**HIGHLANDS COUNTY
BOARD OF COUNTY COMMISSIONERS
(HCBCC)
PURCHASING DIVISION**

BID NO. ITB 20-009

ADDENDUM No. 2

Project: New Public Safety Administration Office

ATTACHMENT A

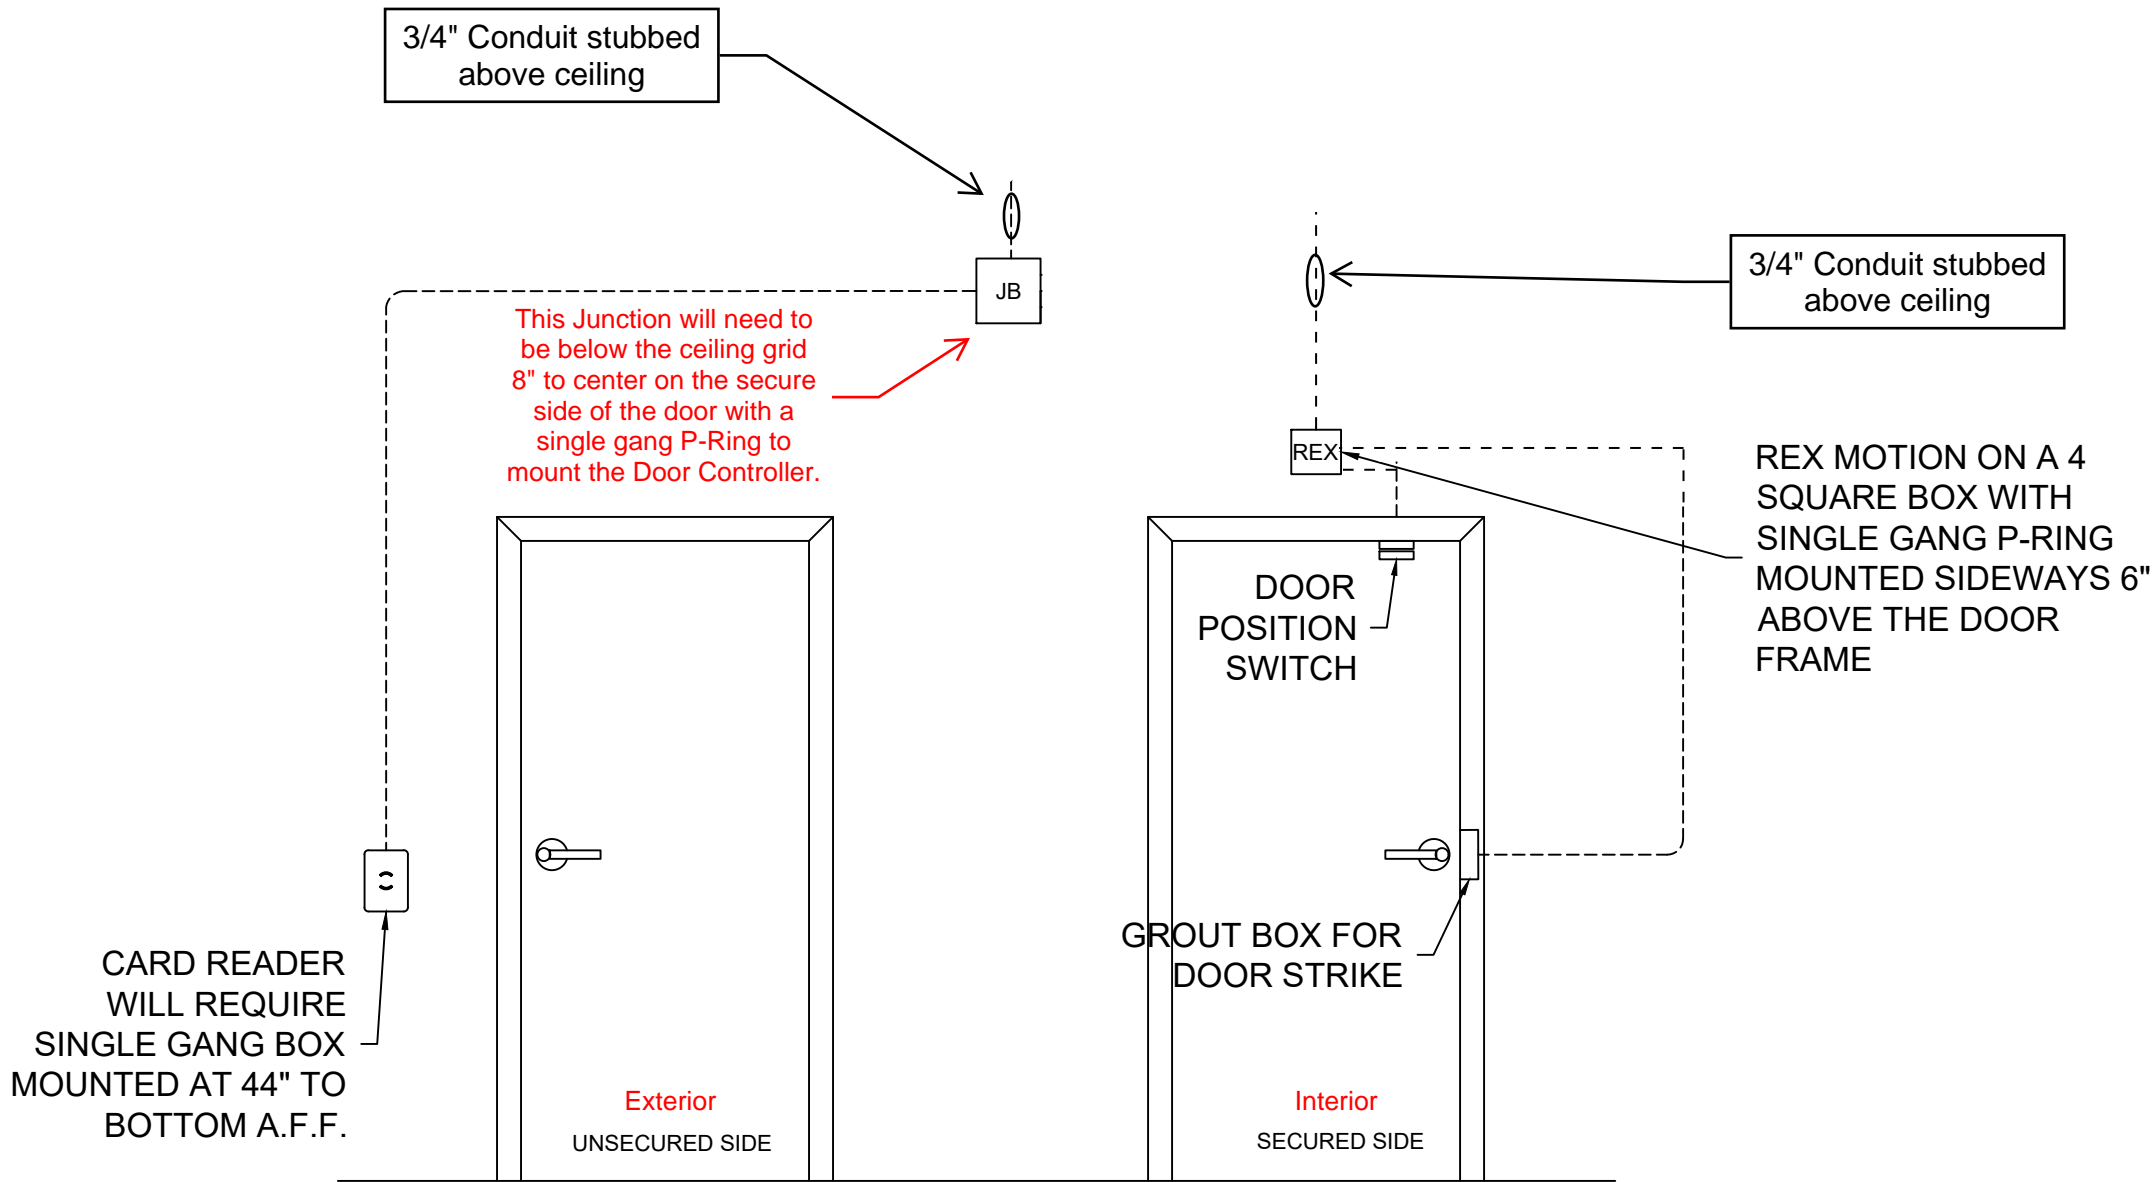
ANSWER: Contractor shall supply the fan. Unit shall be BIGASSFANS, Basic 6, 8 foot diameter.
23. Does the electrical contractor need to install the conduit stubs for the access control devices? If so can more info be given for the access control devices? Height of boxes, size of boxes and size of conduit needed to be stubbed into drop ceiling?

36. Is the County IT Department Supplying the door access (card reader) system?

ANSWER: Please see the attached detail for the raceway and 4sq boxes and/or mud rings needed to be installed by the contractor for the ACS security units at the specified door locations as per the plans. See Attachment A.

ANSWER: Yes, the County's IT Department will be providing the door access control devices through alternate contracts. The contractor for this project is responsible for conduits and boxes as indicated in the plan set. See Attachment A showing door detail.
